18.5 3 ELLIS STREET, CHATSWOOD - PLANNING PROPOSAL

MEETING DATE: 11 FEBRUARY 2019

The purpose of this report is to seek endorsement to not forward the Planning Proposal 2018/0010 for 3 Ellis Street, Chatswood, to the Department of Planning and Environment for a Gateway Determination under Section 3.34 of the *Environmental Planning and Assessment Act 1979* and public exhibition.

Figure 1 – CBD Boundary

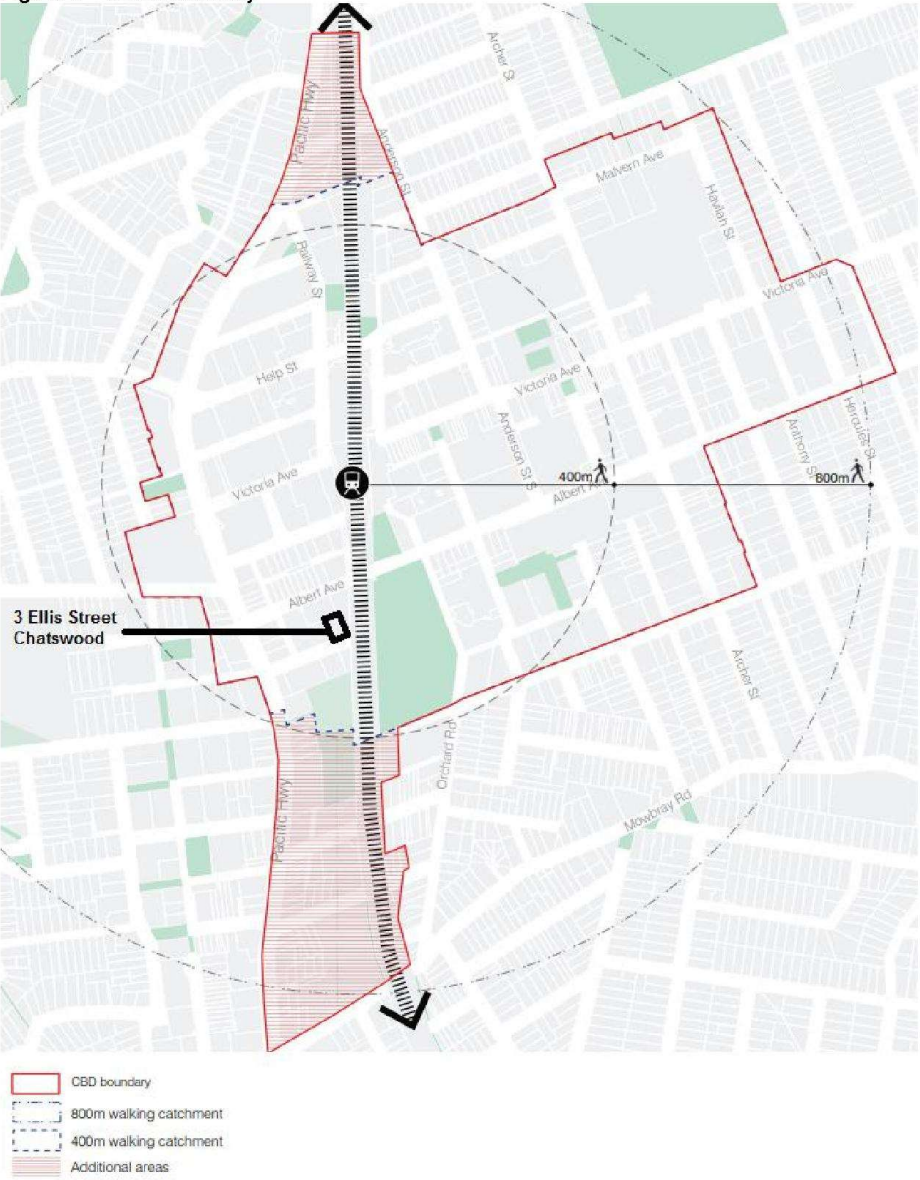
The subject site is located within the existing Chatswood CBD boundary, and the boundary proposed in the *Chatswood CBD Planning and Urban Design Strategy*, as shown below in Figure 1.

Figure 2 – Land Use

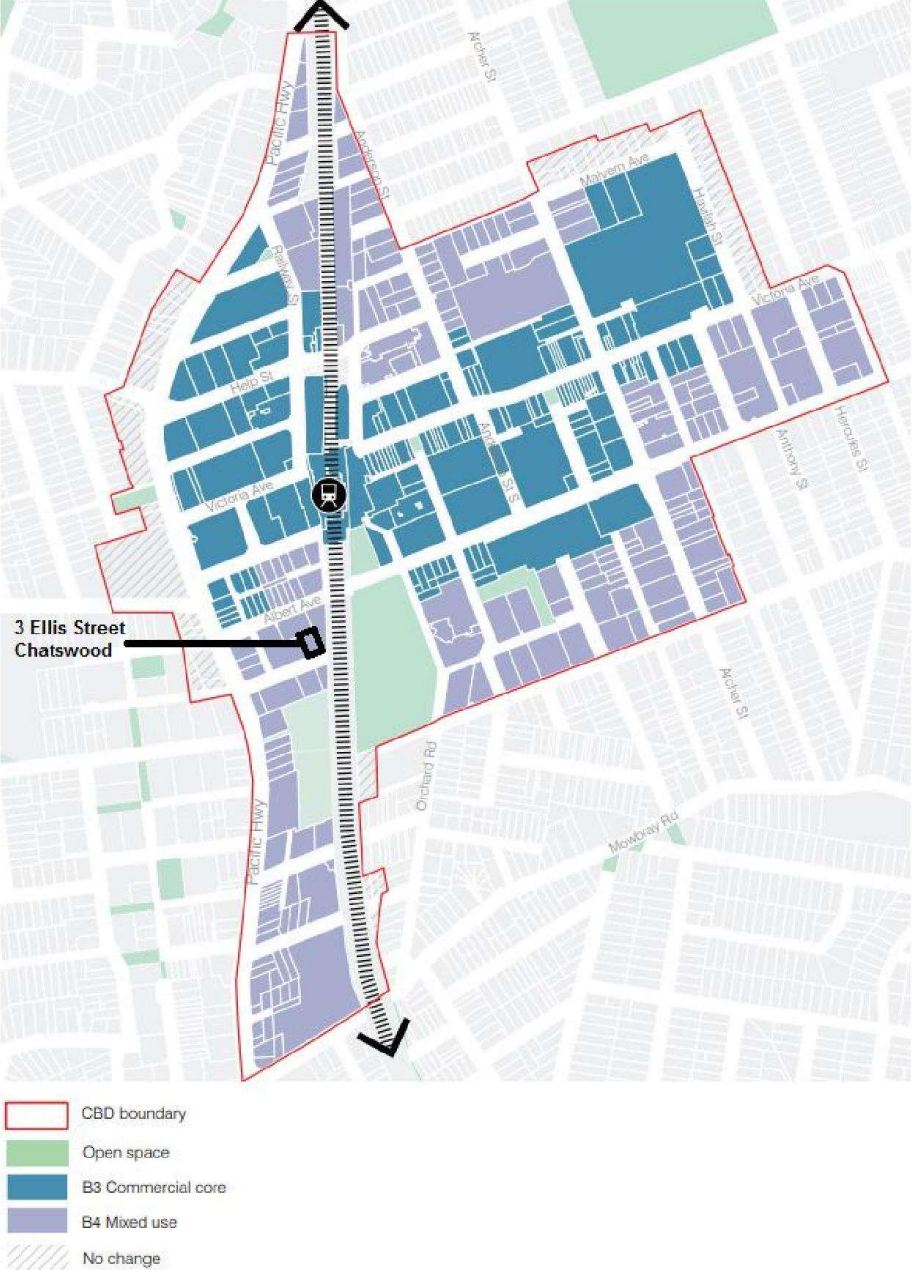
The subject site is located in the R4 High Density Residential zone under *Willoughby Local Environmental Plan 2012* and is located in that part of the Chatswood CBD identified as Mixed Use under the *Chatswood CBD Planning and Urban Design Strategy*, as shown below in Figure 2.

The Planning Proposal proposes residential land use (and no commercial) for the site, which is permitted under *Willoughby Local Environmental Plan 2012* (depending on height and floor space and minimum site area controls) and permitted as part of a commercial and residential mixed use development under Key Element 2 contained in the *Chatswood CBD Planning and Urban Design Strategy*.

Figure 4 – Maximum Floor Space Ratio

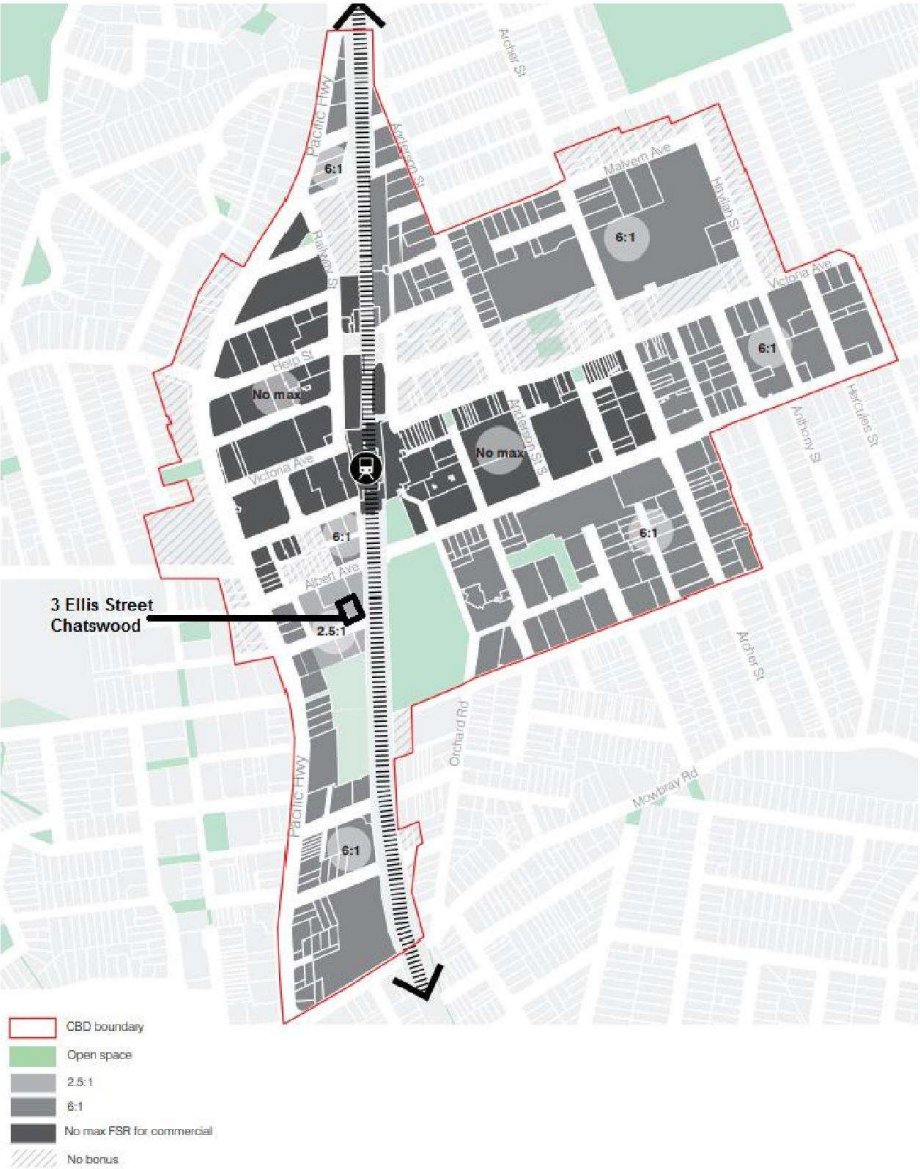
The maximum recommended floor space ratio under the *Chatswood CBD Planning and Urban Design Strategy* for this site and its surrounds is 2.5:1 as shown below is Figure 4, including a minimum floor space ratio of 1:1 for commercial development.

The Planning Proposal proposes a floor space ratio 5.1:1, with no commercial component.

Figure 5 – Sun access

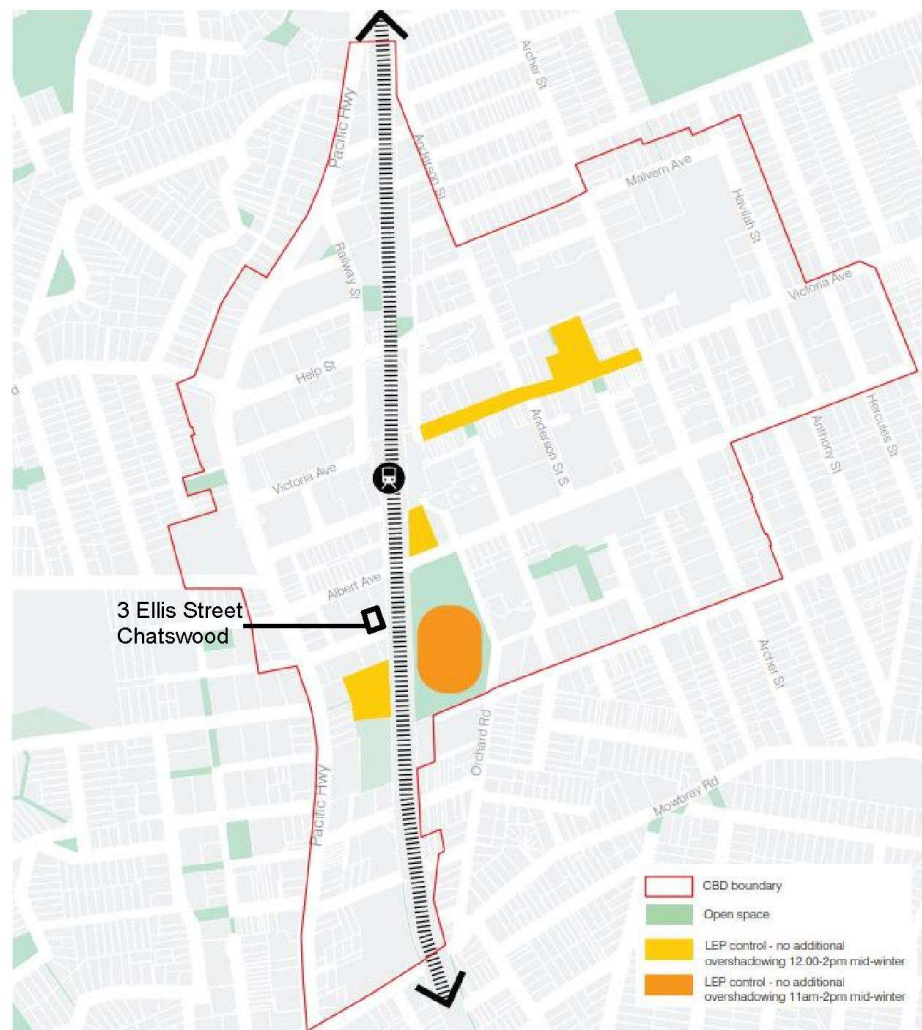
The key public spaces identified within the Chatswood CBD as requiring sun access protection are shown below in Figure 5.

Any overshadowing of key public spaces surrounding this site as a result of the Proposal is not supported, with particular regard to the Tennis and Croquet Club and Chatswood Oval.

The Planning Proposal seeks to establish a 49m height control over the site. There is concern that the Planning Proposal is inconsistent with the *CBD Strategy* (see below) and will result in additional overshadowing to the abovementioned key public spaces.

Figure 7 – Links and New Open Space

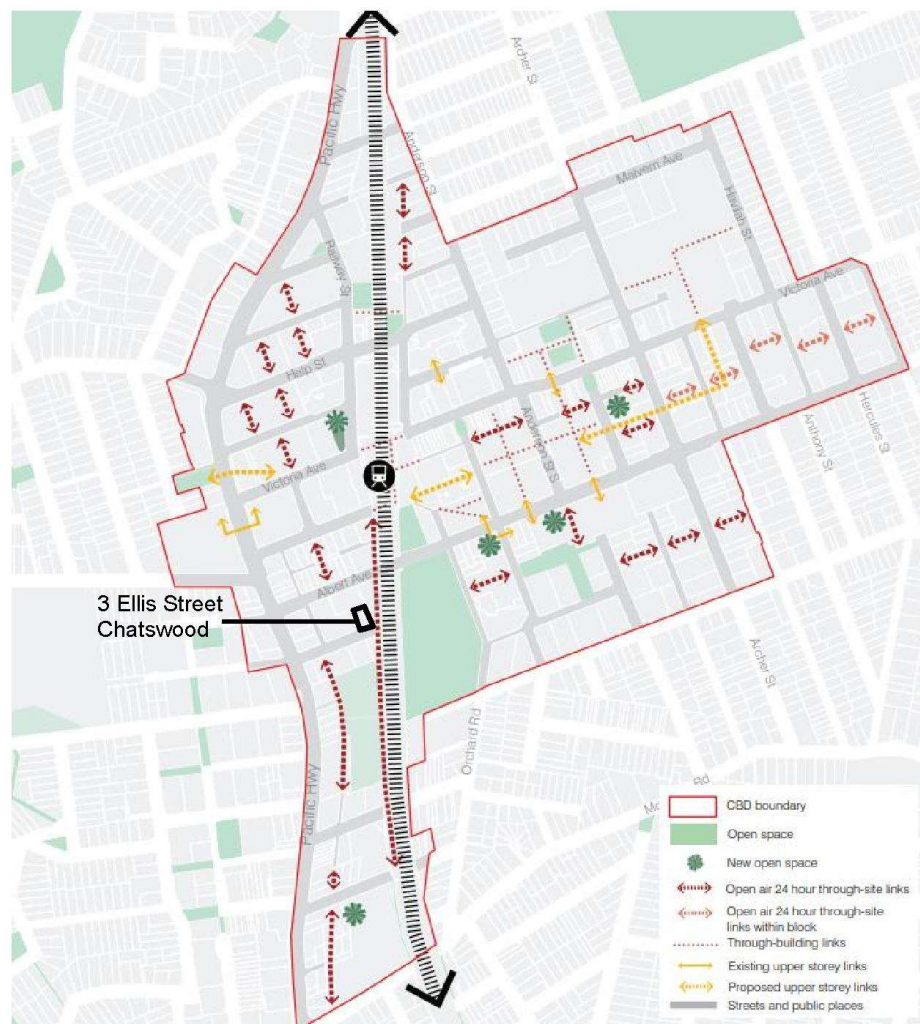
The site is not the subject of an identified sought active linkage. It is noted that the site is within close proximity to the existing Frank Channon Walk adjacent the North Shore Rail Line.

Figure 8 – Street Frontage Heights and Setbacks

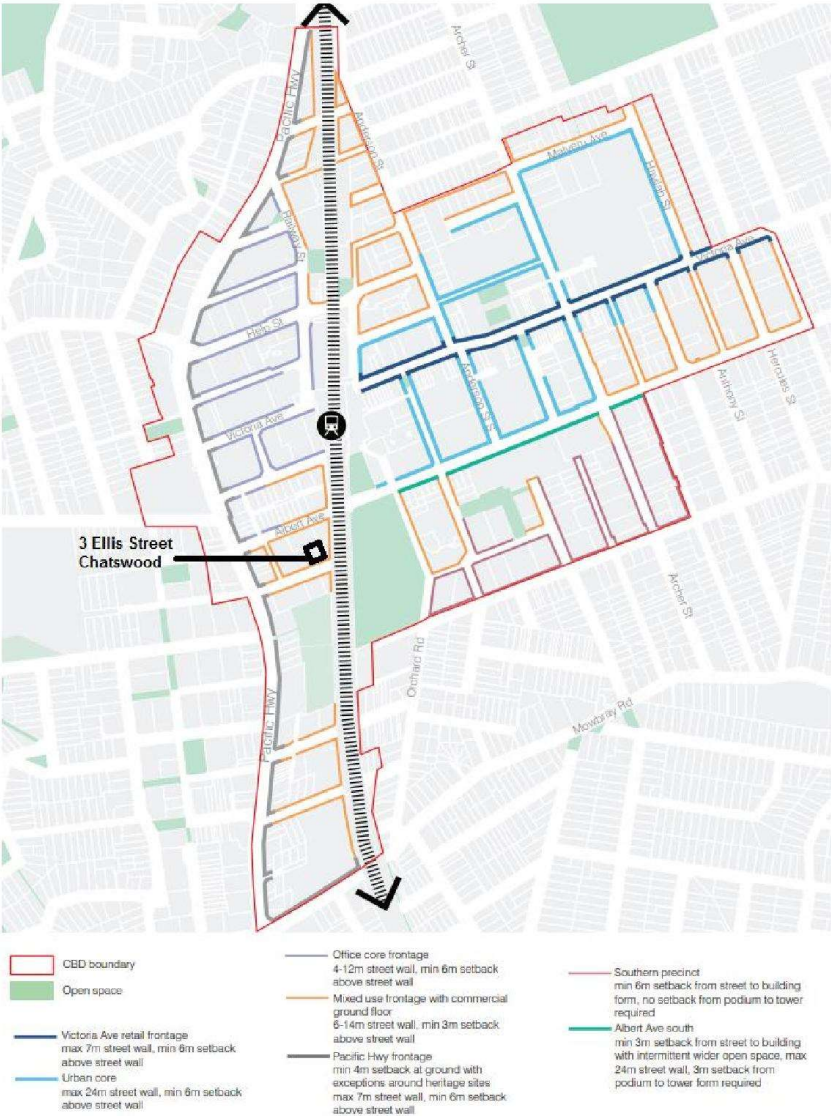
With regard to this key objective, the site is located within the 'mixed use frontage with commercial ground floor' as shown below in Figure 8 below.

The site proposes no mixed use commercial frontage.
